Application for Works Approval Amendment

Works Approval Number	W6641/2022/1
Works Approval Holder	Iluka Rare Earths Refinery
ACN	654 487 662
File Number	INS-0002523 (APP-0033449)
Premises	Eneabba Rare Earths Refinery Part of Mining Lease M267SA ENEABBA WA 6518 As defined by the premises maps attached to the revised works approval
Date of Report	28 May 2026
Decision	Revised works approval granted

Figure 1: Updated ERER emission source locations.

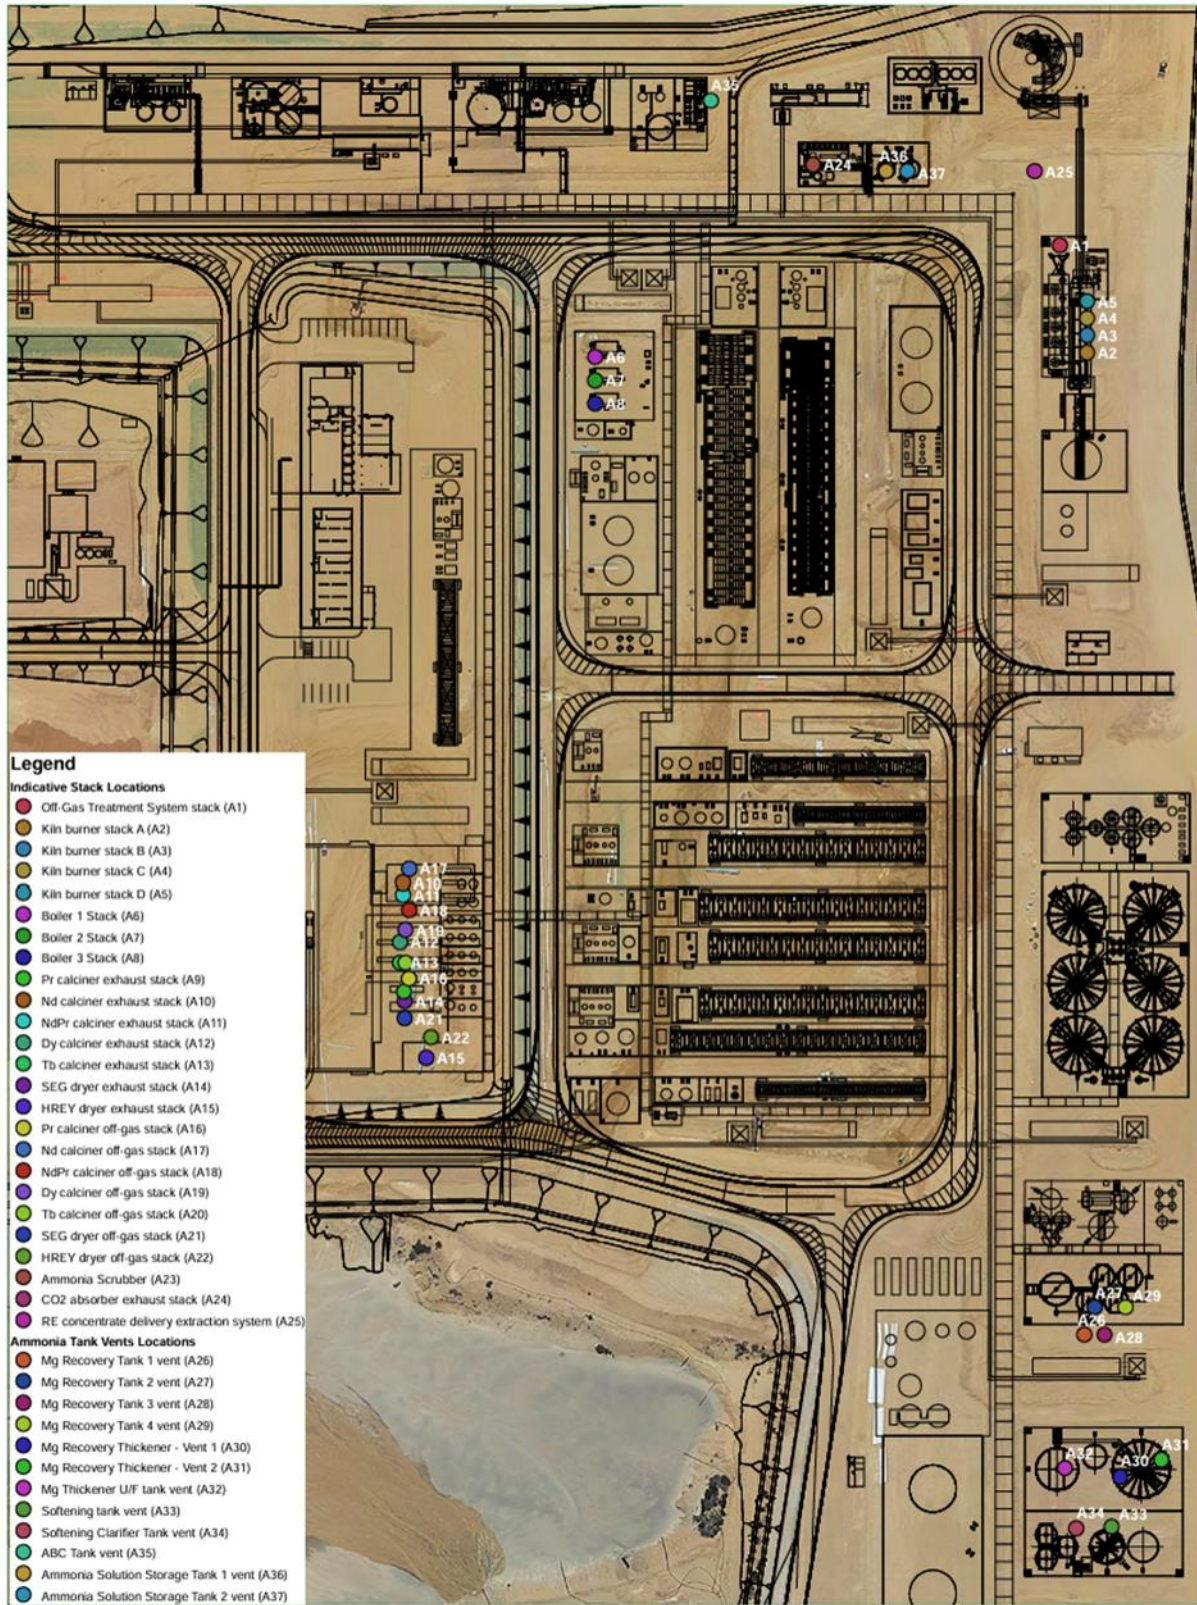
- The removal of the magnesia recovery circuit scrubber (ammonia scrubber 2) and redirect emissions from this circuit to the atmosphere via new vents.

The ammonia vapour concentrations from the magnesia recovery tank vents were found to be lower than anticipated when the works approval holder analysed refinery operating conditions. Therefore, the works approval holder has proposed to remove ammonia scrubber 2 from the refinery scope.

- Minor amendments to the coordinates of the existing stack locations to align with the final refinery equipment locations, as shown in Figure 1.
- Increase the minimum stack heights for the ammonia scrubber, kiln burner stacks A-D, calciner exhaust stacks, dryer exhaust stacks, off-gas stacks and rare earth (RE) concentrate delivery extraction system.
- Increase the maximum stack diameters for the off-gas treatment system stack, calciner exhaust stacks, dryer exhaust stacks, off-gas stacks, ammonia scrubber and RE concentrate delivery extraction system.
- Decrease the maximum stack diameters for the kiln burner stacks A-D, boiler stacks 1-3 and CO₂ absorber exhaust stack.
- Amend the emission parameters to align with the updated air emissions modelling for the kiln burner, boiler, calciner and dryer stacks and associated off-gas stacks, outlined in Section 3.2.
